TFVS-04-12
Management of
Noise emissions according to UN-R51-03 at low speeds
vs. AVAS compliant to UN-R138

Matching AVAS Requirements (UN R138) with RD-ASEP (UN-R51) Background “Minimum Sound Requirements”

Approach for Clarifications in UN R138.01

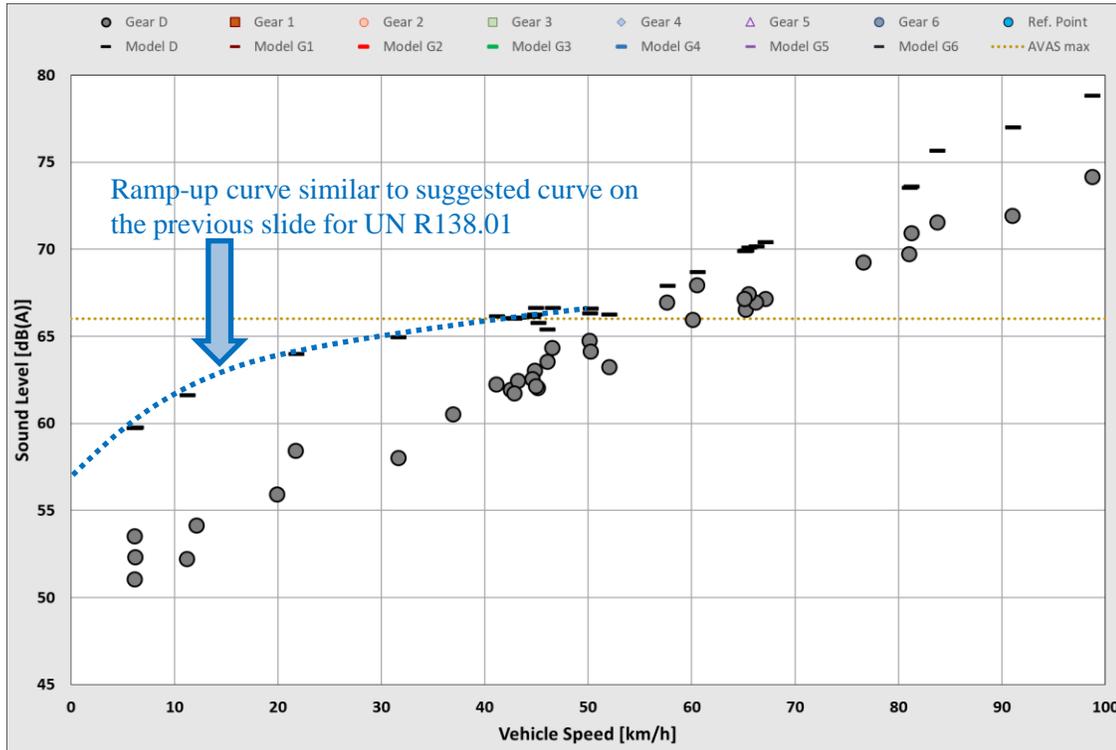
For clarity, the following modifications to UN R138.01 could be considered

- The AVAS operation range is expanded on the basis of the NHTSA model based on UN R138.01 minimum sound levels to allow manufacturer a matching with existing regulations.
- Minimum sound is defined up to 40 km/h.
- Maximum sound no longer constant, but ramped-up from > 0 km/h to 40 km/h and cannot become louder beyond 40 km/h.
- Maximum sound is applicable to any driving condition up to 3 m/s² acceleration, not only to constant speed.
- Vehicles which are equipped with an AVAS fully compliant to these provisions are exempted from RD-ASEP.
- Sound enhancement systems which are operational beyond that speed range are subject to UN R51.03 RD-ASEP → **SEE NEXT PAGE**

Reflection of AVAS and Sound Enhancement Systems into RD-ASEP

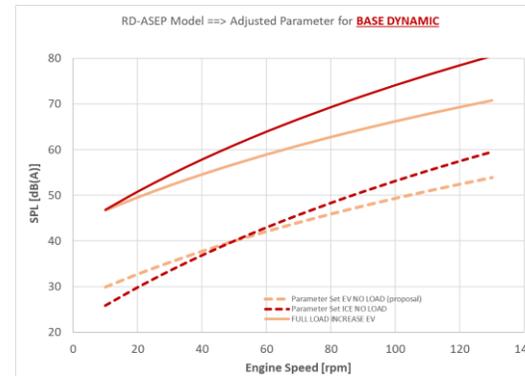
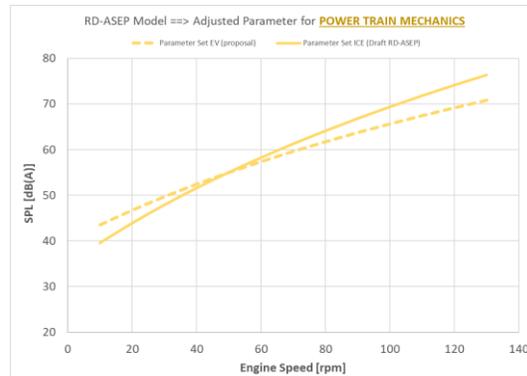
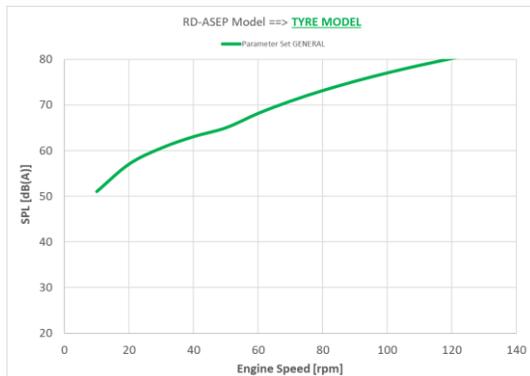
- The AVAS max sound ramp-up principle can be established in RD-ASEP by creating a transient between UN R138 to UN R51.04 RD-ASEP.
- The ramp-up function is only applicable to vehicles equipped with AVAS devices which exceed the UN R138.01 application range.
- In addition, the parameter table should be modified for electric vehicles
 - The slope of powertrain mechanics for operation conditions greater than the anchor point is lowered from 115 to 85.
 - The slope of base dynamics for operation conditions greater than the anchor point is lowered from 105 to 75.
 - EVs should be **MANDATED** to take measures to restrict the maximum acceleration during the test to 3 m/s².
 - The rating factor for performance is increased from 10 to 16

The suggested parameter for EVs set the power train and its dynamic in a way, that tyre rolling sound remains always the dominant source.
